PRODUCT CHANGE NOTICE

PCN#20-047

NOTIFICATION DATE: October 14, 2020

EXTENT OF CHANGE:

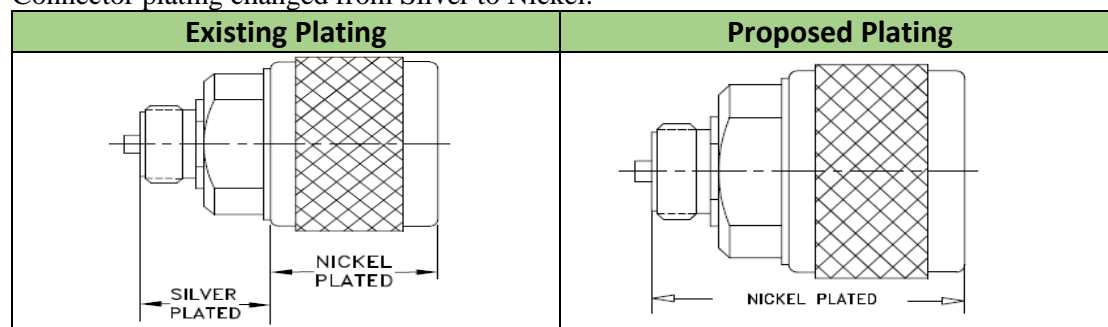
Connector plating changed from Silver to Nickel.

No change to **FIT** (dimension) & **FUNCTION** (performance).
 Change to **FORM** (plating change)

Uniformity of plating with knurled ring.
